IRIGARAY URANIUM SOLUTION MINING PROJECT

WYOMING MINERAL CORPORATION**SEPTEMBER 1978****Docket No. 40-8502****U. S. Nuclear Regulatory Commission****Office of Nuclear Material
Safety and Safeguards**

FINAL ENVIRONMENTAL STATEMENT
related to the
WYOMING MINERAL CORPORATION
IRIGARAY URANIUM SOLUTION MINING PROJECT

After comments on the Draft Environmental Statement had been received and considered, the staff prepared this Final Environmental Statement. It includes discussion of questions and comments submitted by reviewing agencies or individuals. Further environmental considerations are made on the basis of these comments and combined with the previous evaluation; the total environmental costs are then evaluated and weighed against the environmental, economic, technical, and other benefits to be derived from the proposed project. It is concluded (Sect. 13) that the overall benefit-cost balance for the limited Irigaray project is favorable and that the indicated action is that of granting a source material license for the Irigaray project.

Fig. 2.16. Geologic cross sections A-B and B-C (Fig. 2.15) at the Irigaray site. Source: ER, Figs. 3-4 and 3-5.

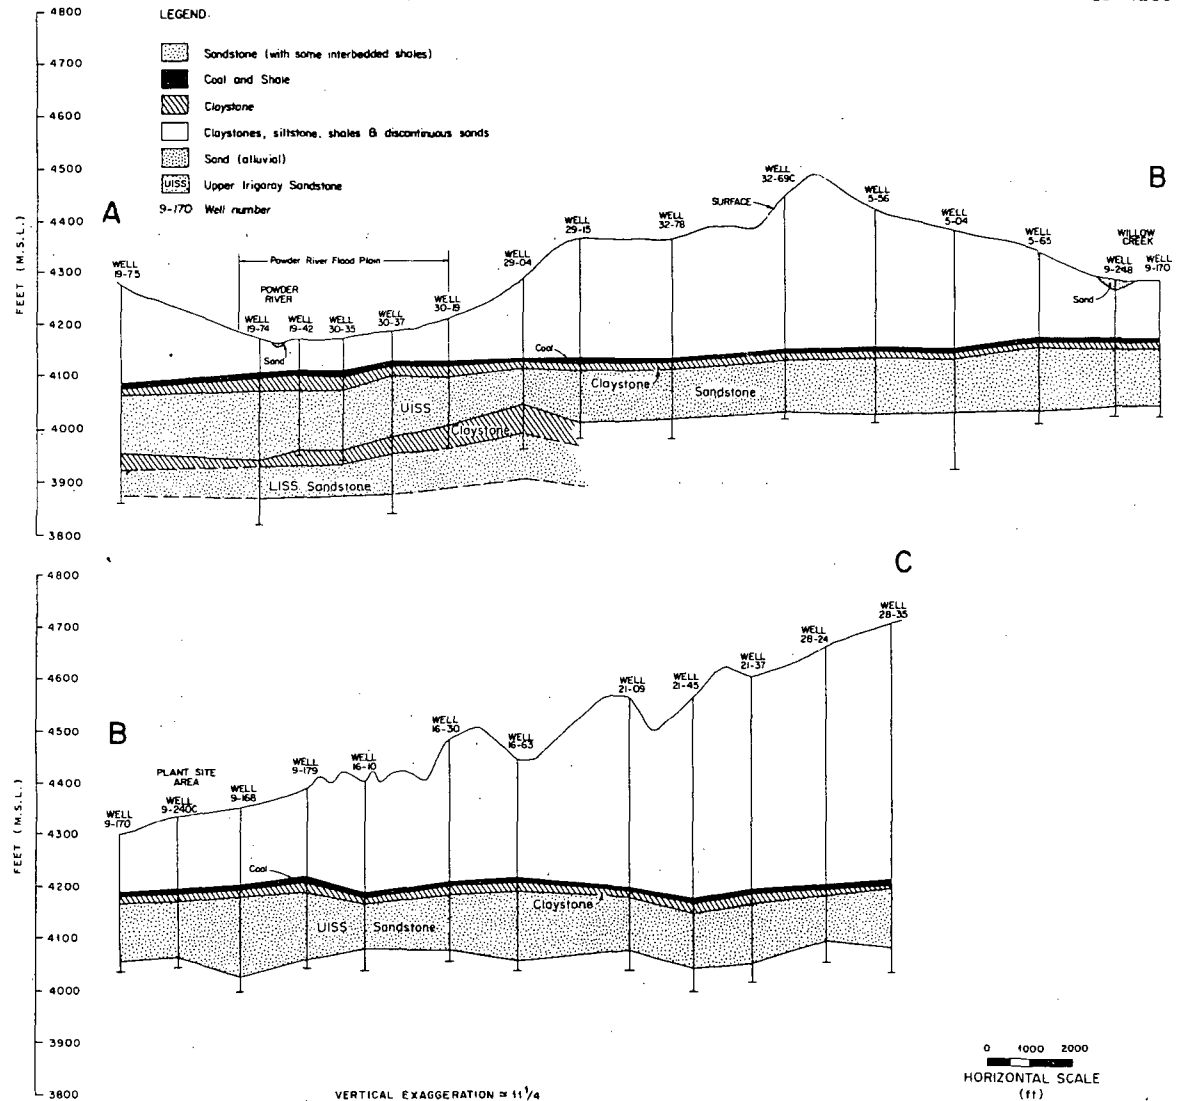
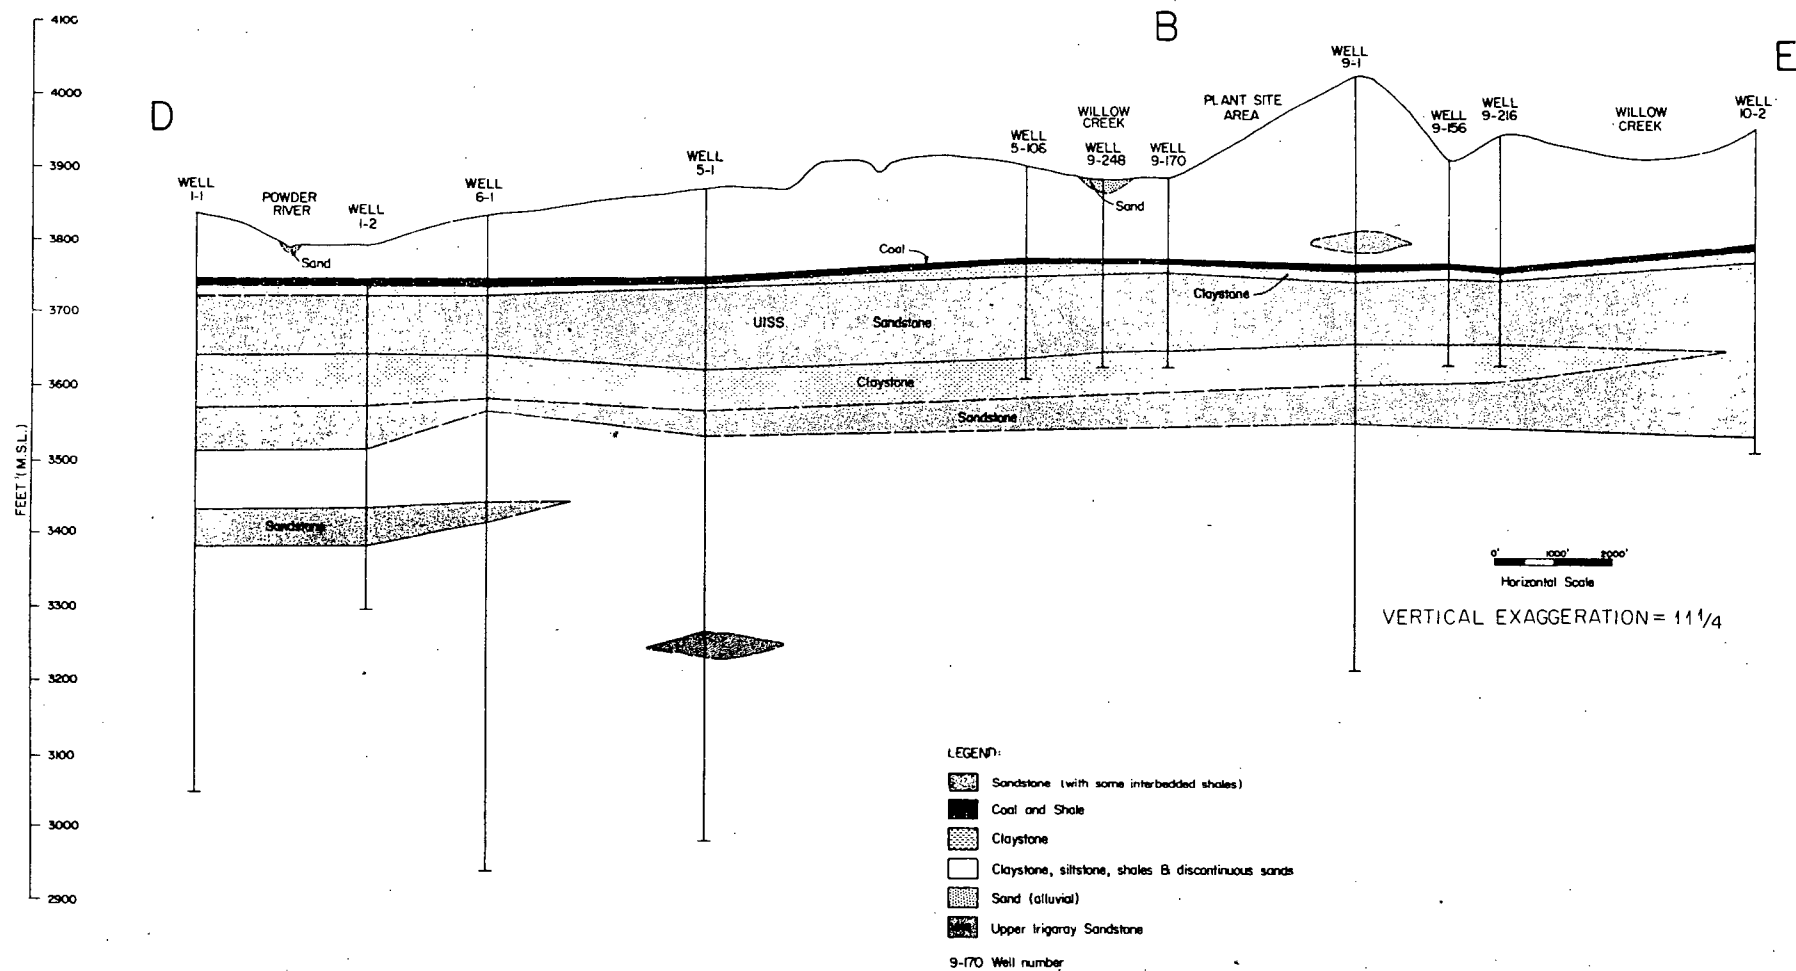
Page 2-18, Section 2.7.1. The data on the geology at the plant site appears sketchy and should be amplified. There should be some data on the extent of alluvial materials in the area. It is hard to envision that the claystone overlying the ore body is as continuous as is shown on Figure 2.16 and 2.17, given the type of depositional history of the Wasatch Formation. Also, the lack of data on the nature of the materials overlying the coal unit makes it difficult to make a judgement on the groundwater hydrology of the entire unit. It would be helpful if the FES included a table which lists the detailed logs for each of the drill holes, shown in the cross sections. In addition, there should be some discussion on the integrity of the claystone and the coal seam as far as the degree of fracturing that may be present in the site area.

Figures 2.16 and 2.17 show no evidence of a connection between the alluvium in the creek bottom and the uranium-bearing aquifer. In addition, baseline surveys as recommended in Section 8.1.5.3 will also generate data to assess any impacts.

Figures 2.16 and 2.17 show the continuity of the claystone overlying the Upper Irigaray sandstone. The extent of the claystone unit underlying the Upper Irigaray sandstone is discussed on p. 2-22 of the DES.

Fig. 2.20. Typical food web of livestock ponds in Campbell and Converse counties. Source: Applicant's Environmental Assessment for a Proposed Gasification Project in Campbell and Converse Counties, Wyoming, prepared for Wyoming Coal Gas Company and Rochelle Coal Company by SERNCO, Inc., 1974.

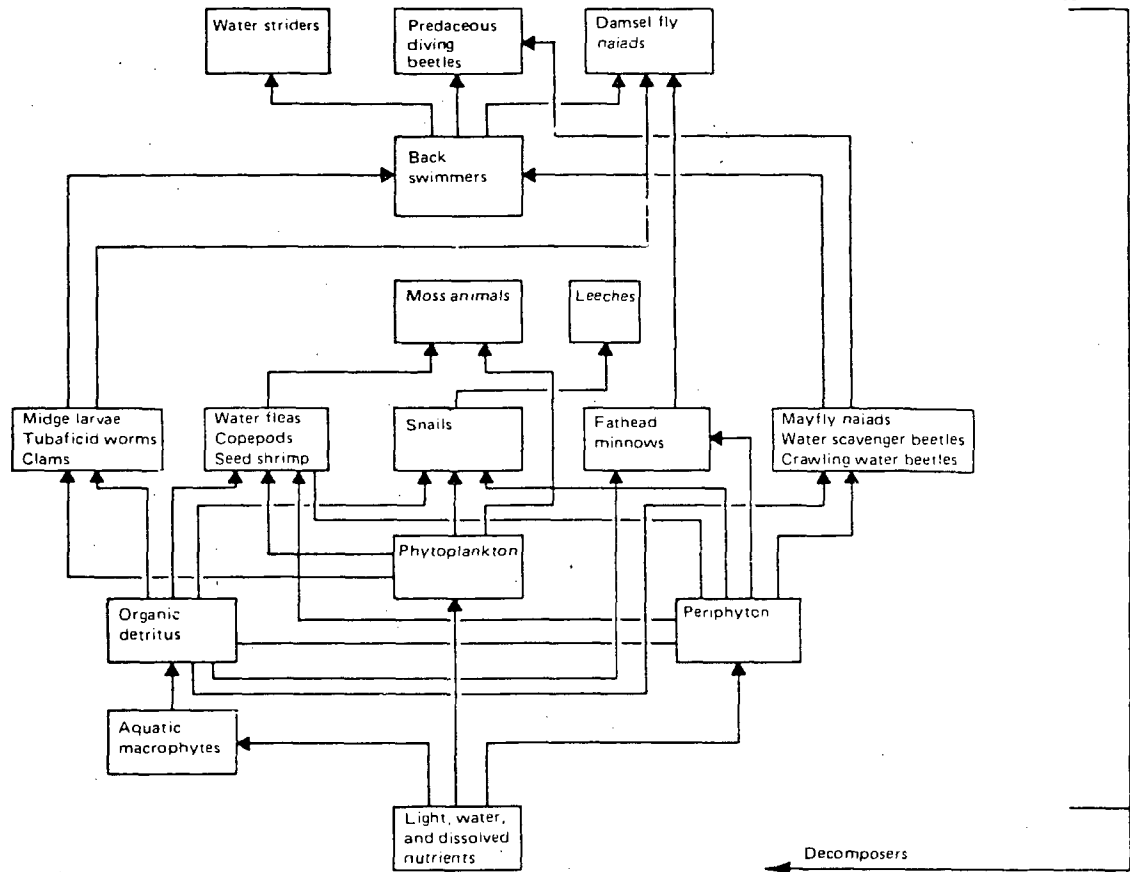
Pp. 2-33, Figure 2.20 is a nice flow chart for a typical food web in livestock ponds; however, it doesn't depict an impact assessment on the aquatic habitats of concern.

Pp. 2-33. Figure 2.20 is a nice flow chart for a typical food web in livestock ponds; however, it doesn't depict an impact assessment on the aquatic habitats of concern.

Fig. 4.1. Potential mining and drilling schedule for the Irigaray site. Source: Modified from ER, Fig. 4-1.

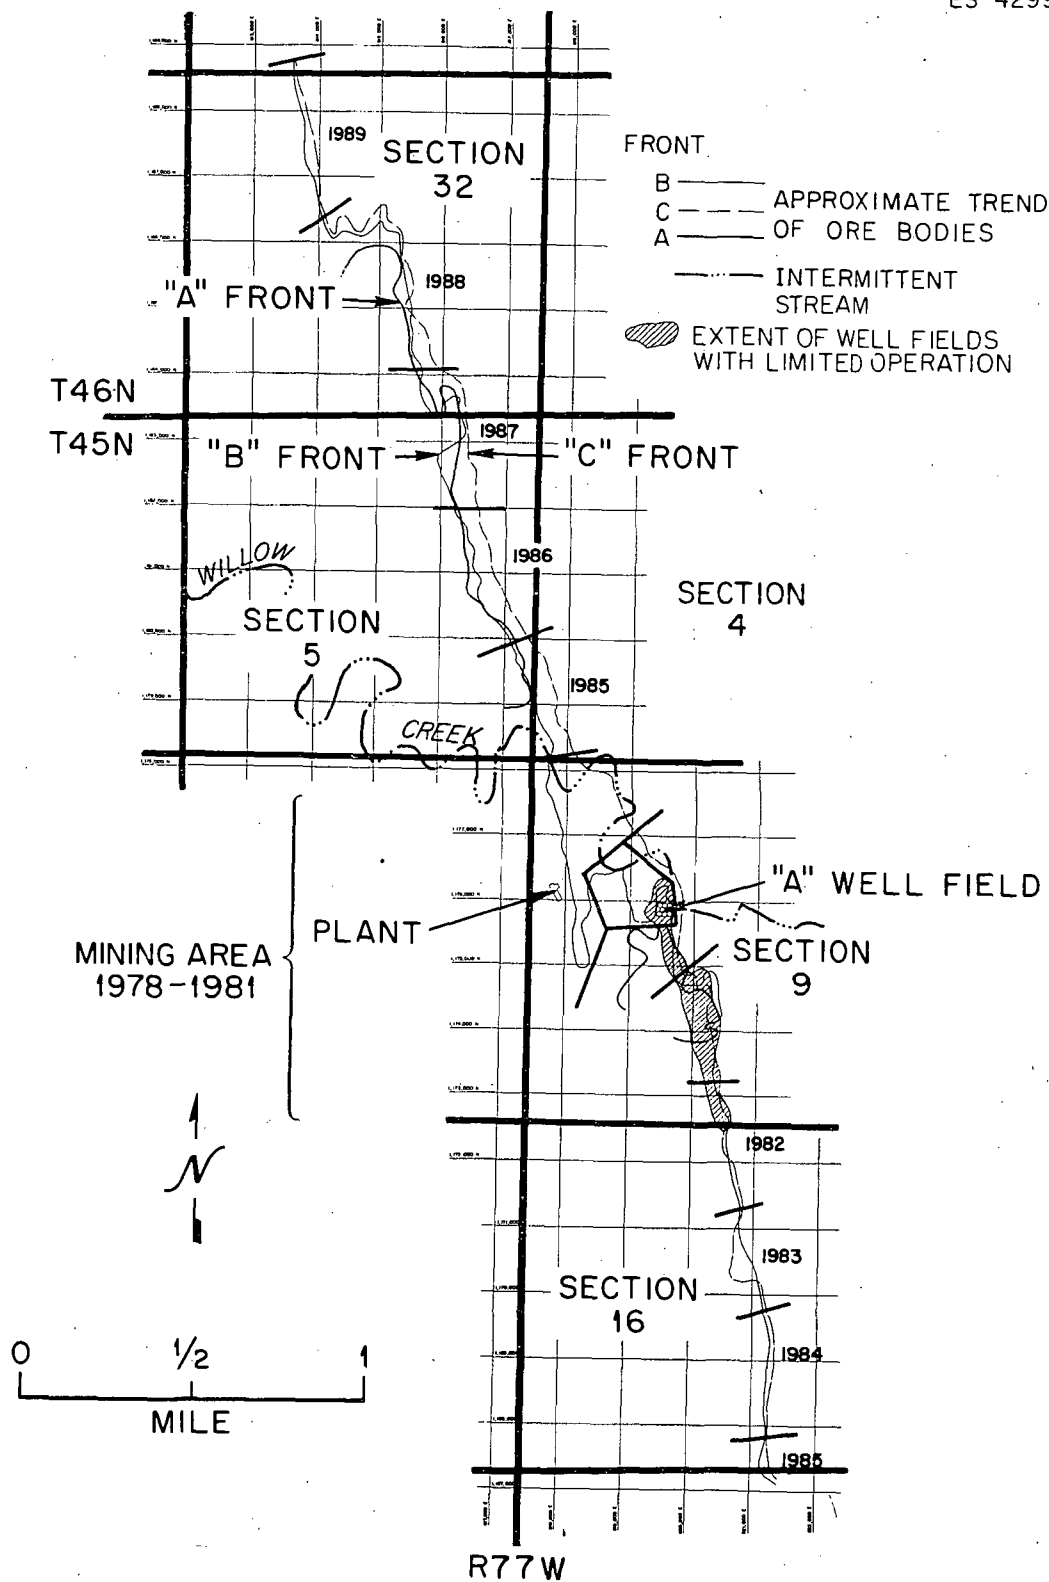
Paragraph 4.3.1 (page 4-1), Figure 4.1 (page 4-2) and Subparagraph 4.3.4.2 (page 4-7). (New information). WMC's latest proposed mining schedule is shown on the drawing entitled "General Mine Plan," dated 3/17/78. This drawing is enclosed.

Figure 4.1 and Sect. 4.3.4.2 have been revised to reflect this new information.

Fig. 4.5. Diagram of well completion methods. Provided by the applicant.

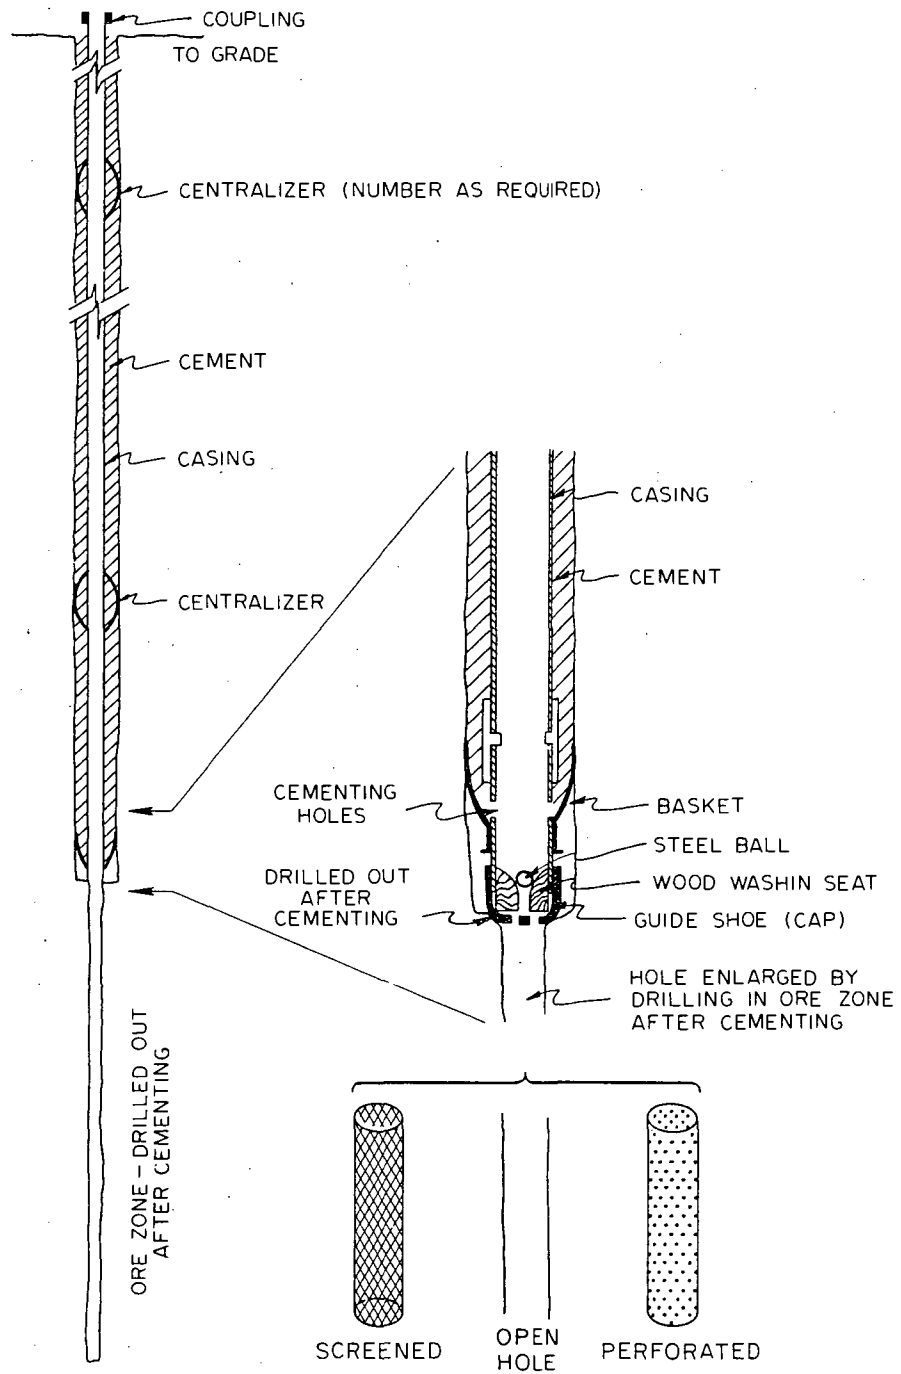
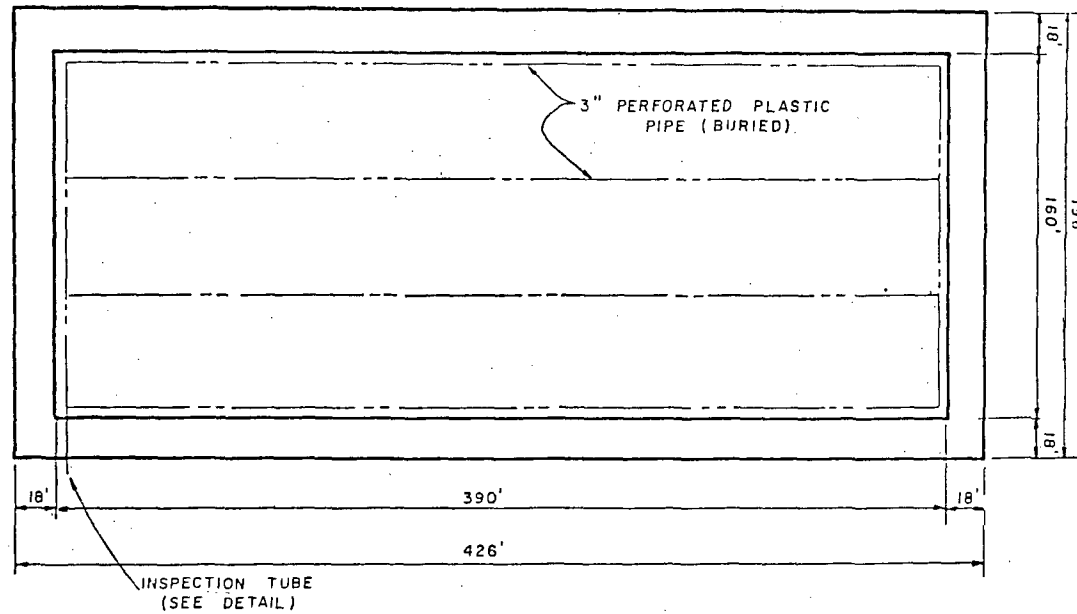
Figure 4.5 (page 4-6). (Clarification). WMC has enclosed a drawing entitled "Revised Fig. 4.5 Diagram of Well Completion Methods" that more accurately describes the well completion method used at Irigaray.

A notation has been made on Figure 4.5 referring to the revised figure.

Fig. 4.6. Schematic diagram of the applicant's uranium recovery process, showing approximate volume flow rates. Source: Modified from ER, Fig. 2-9.

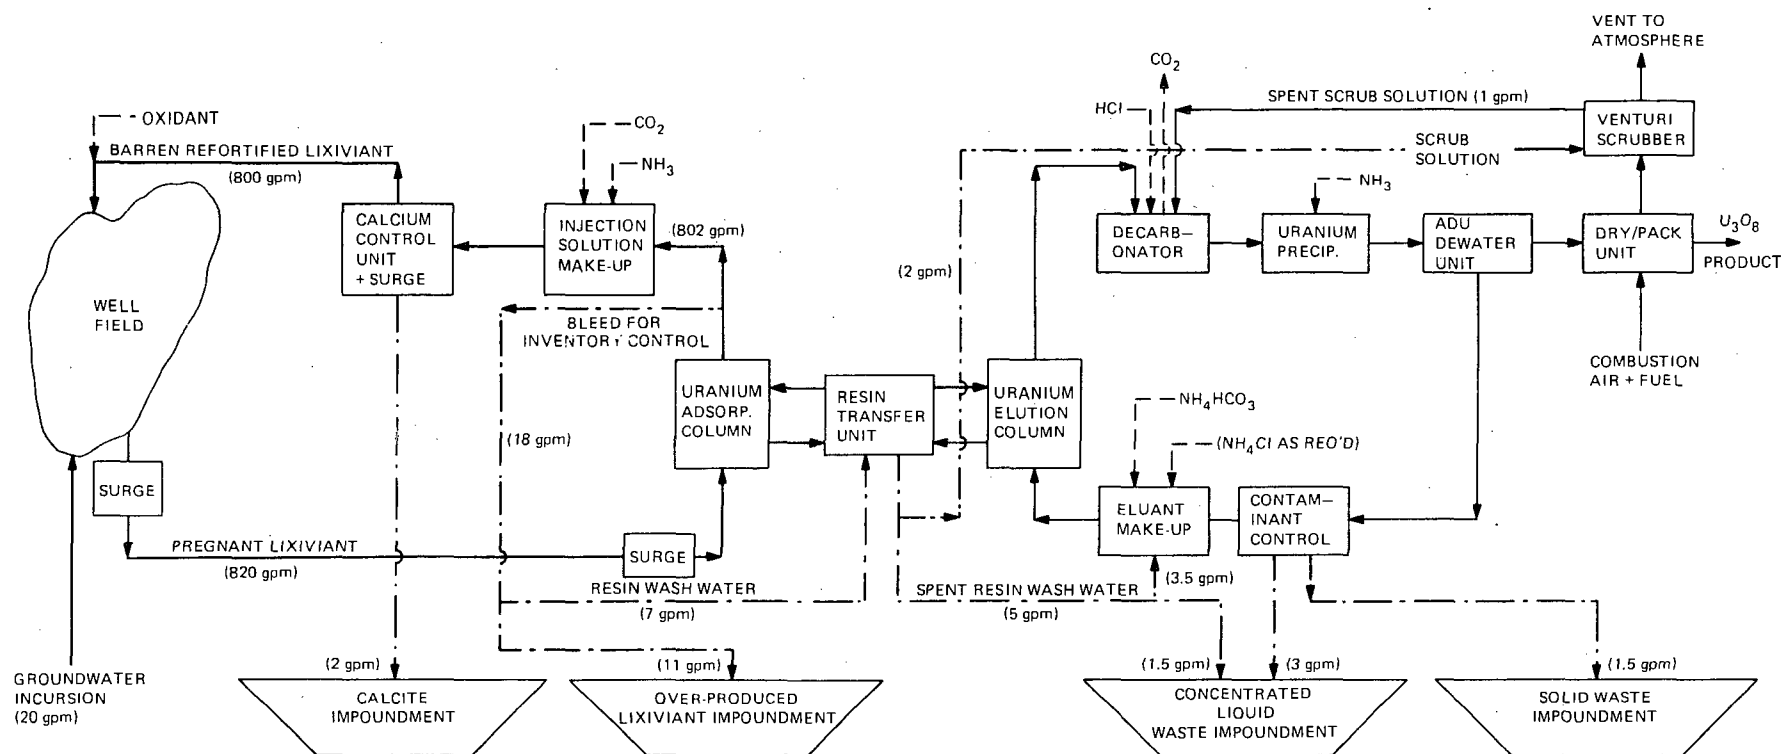
Figure 4.6 (page 4-9), Paragraph 4.4.3 (page 4-10), Section 4.5 (page 4-10). (Clarification). Please note that the governing parameter for the processing plant is the uranium output. Uranium output is dependent on the uranium concentration in the feed solution and the flow rate of that solution. For the recovery plant, the flow rate is adjusted by changing the number of production cells being pumped and fed into the recovery process. We wish to emphasize that the cell flow rates are not necessarily related to the plant flow rates. Also, the plant flow rate during production activities may deviate substantially, depending on the concentration of the dissolved uranium that occurs in the pregnant lixiviant. As well fields are drilled, and permeability and grade determinations are completed, flow adjustments will have to be made to maintain projected uranium output.
